CLEVELAND NATIONAL FOREST POWER LINE REPLACEMENT PROJECTS

MINOR PROJECT REFINEMENT REQUEST FORM

Date Submitted:	01-22-18	Request #:	012
Date Approval Required:	02-05-18	Landowner:	XXX
APN:	XXX-XXX-XX, XXX-XXX-XX, and XXX-XXX-XX		
Refinement from (check all that apply):			
<input type="checkbox"/> Mitigation Measure	<input type="checkbox"/> APM	<input checked="" type="checkbox"/> Project Description	<input type="checkbox"/> Drawing
Identify source (mitigation measure, project description, etc.):			
<p>In April 2015, San Diego Gas & Electric Company's (SDG&E's) responses to Data Request #10 were submitted to the California Public Utilities Commission (CPUC). The responses included Attachment B.10 C442 Route Map¹ for the Cleveland National Forest Power Line Replacement Projects (Project), which depicted approved staging and fly yards. Pages B-45 and B-46 of the Final Environmental Impact Report/Environmental Impact Statement (EIR/EIS) state that the Project's staging yards will be used for storage and preparation of construction materials, including replacement poles, conductors, and construction equipment before delivery to the individual pole work areas; and the Project's fly yard

Attachment C: Survey Area Map
Map 1 of 1

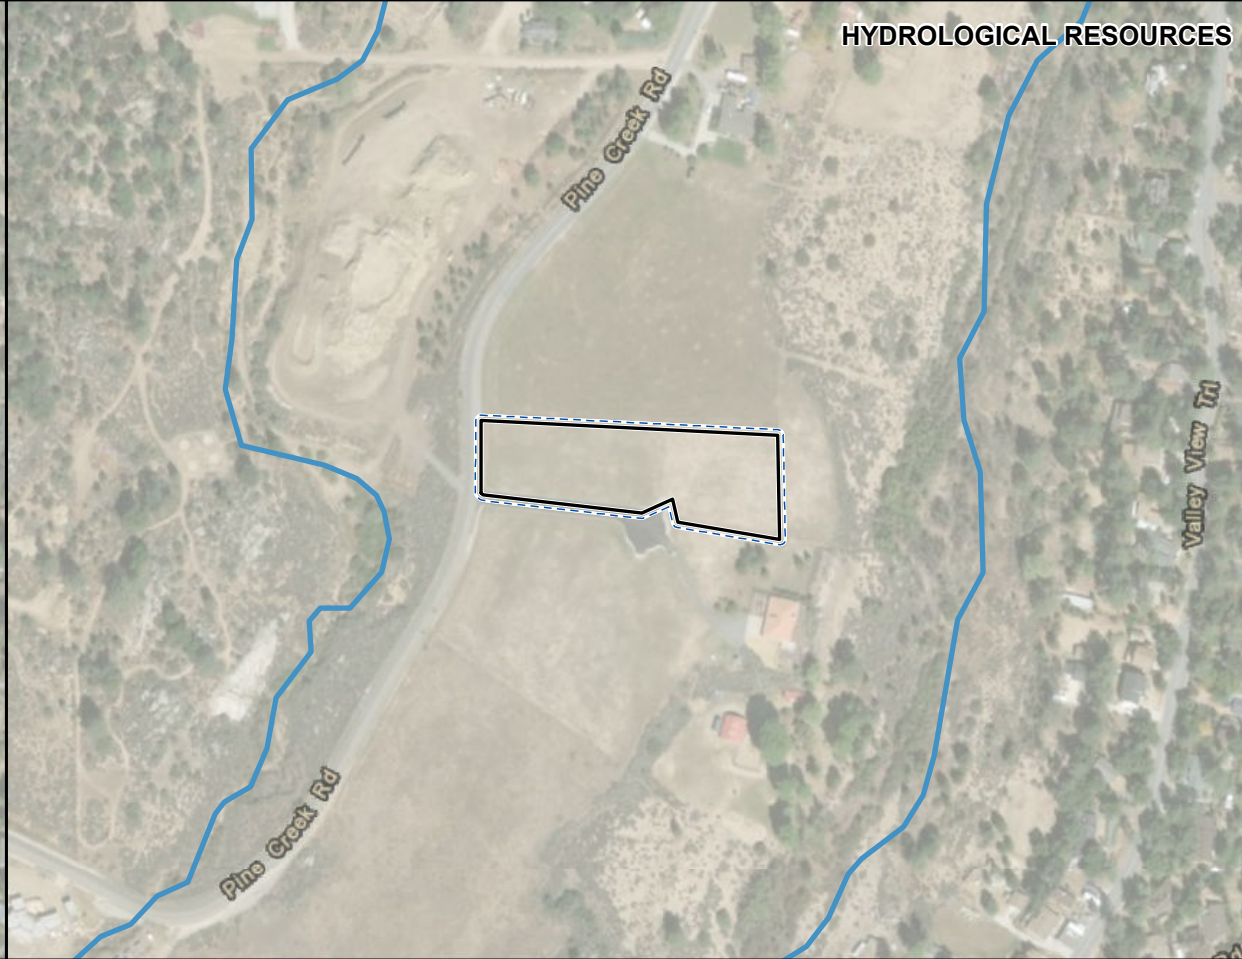
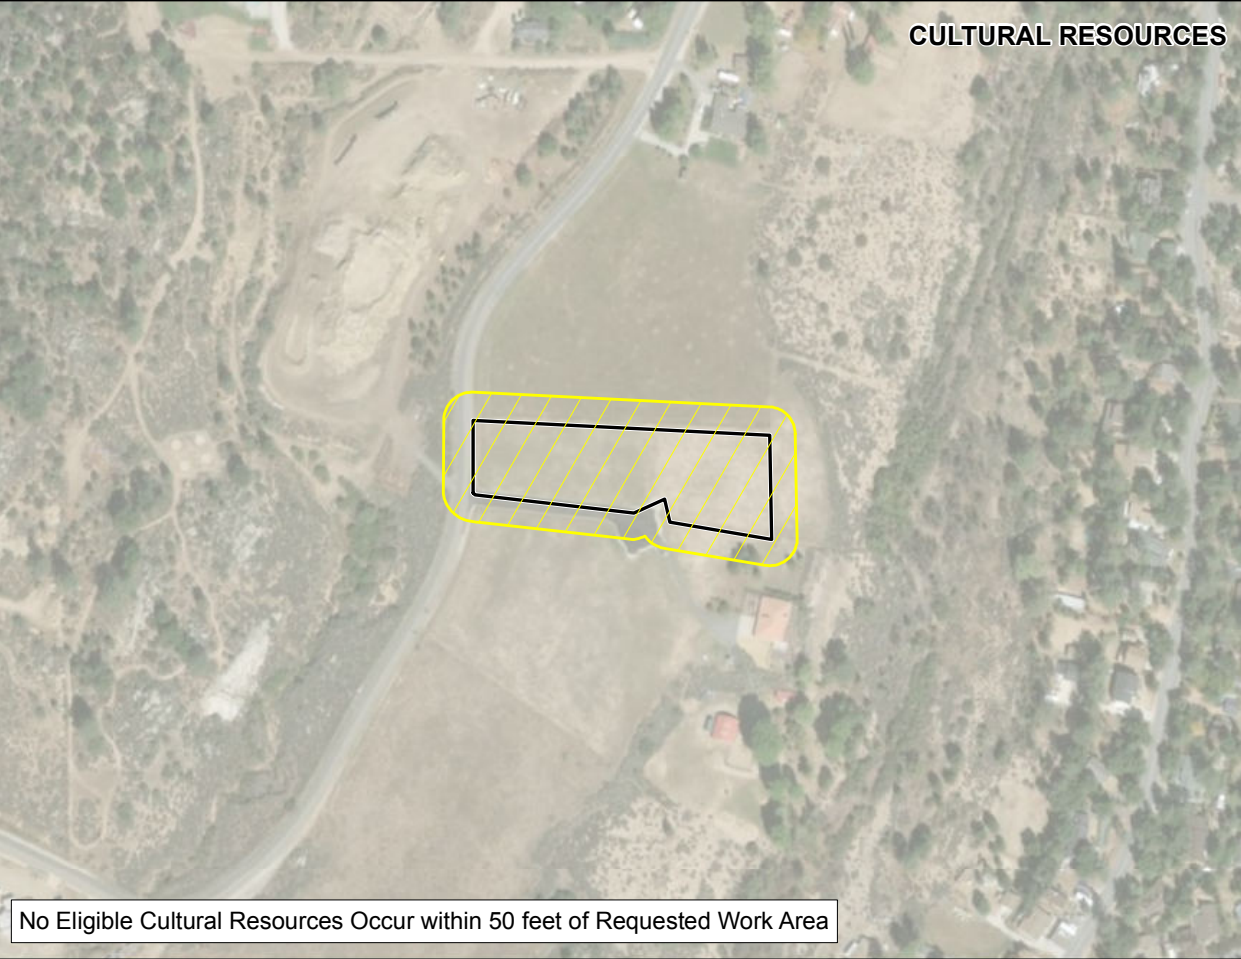
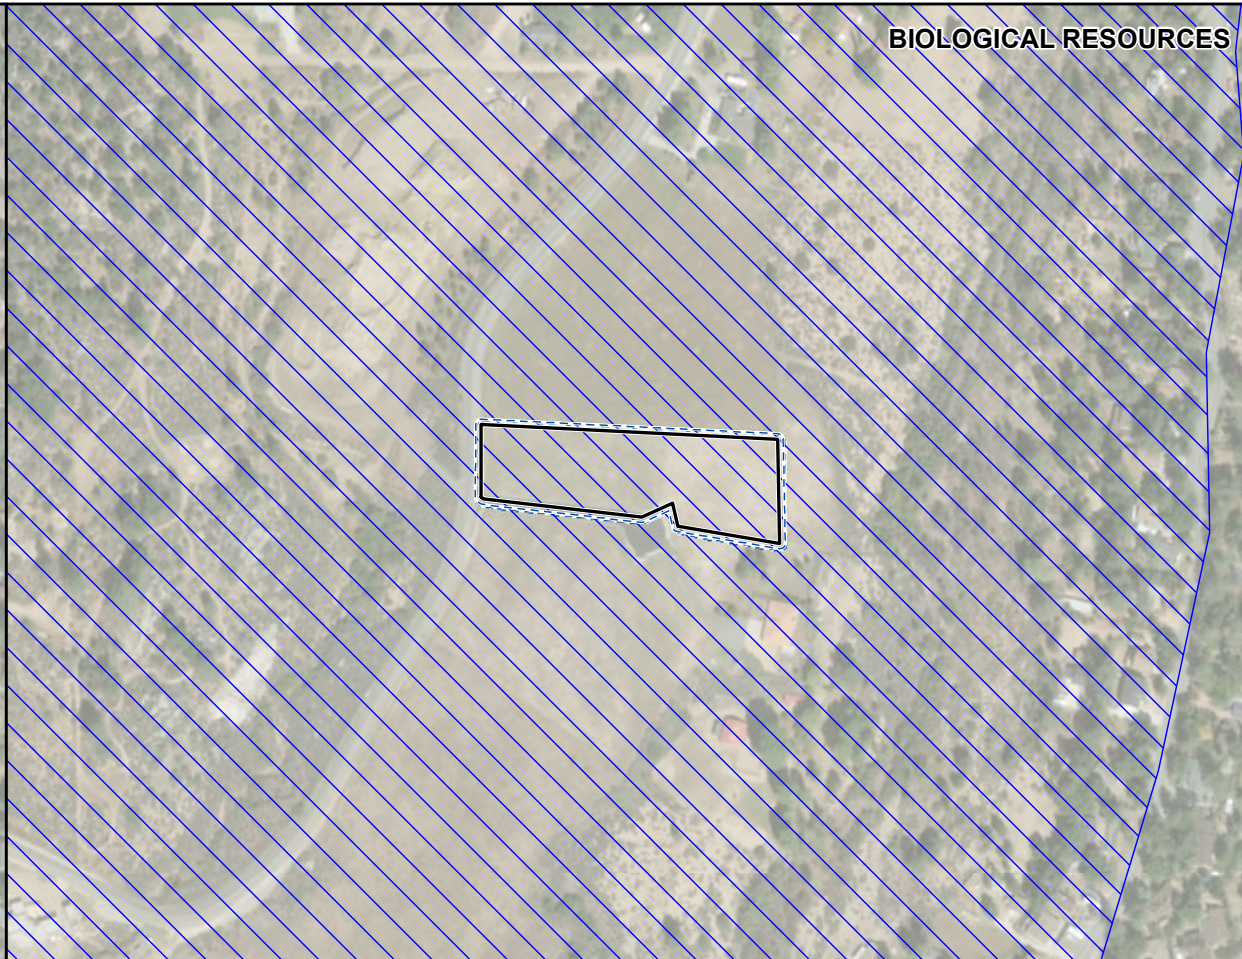
A staging yard on the northern section of C442 was approved as part of the 2015 baseline data; however, it is not large enough to support helicopter operations and contains sensitive biological habitat. Therefore, the Creekside Ranch Staging and Fly Yard is requested to provide additional space for helicopter activities and materials storage to support construction on the northern section of C442. The yard will also be used to aid construction on TL629A due to its close proximity to the alignment.				
Date refinement is expected to be implemented:		02-12-18		
Resource Agency Coordination				
Resource Agency	Name	Action Required	Date	Documentation (see attached if yes)
Not Applicable (N/A)	N/A	N/A	N/A	<input type="checkbox"/> Yes <input type="checkbox"/> No

No Eligible Cultural Resources Occur within 50 feet of Requested Work Area
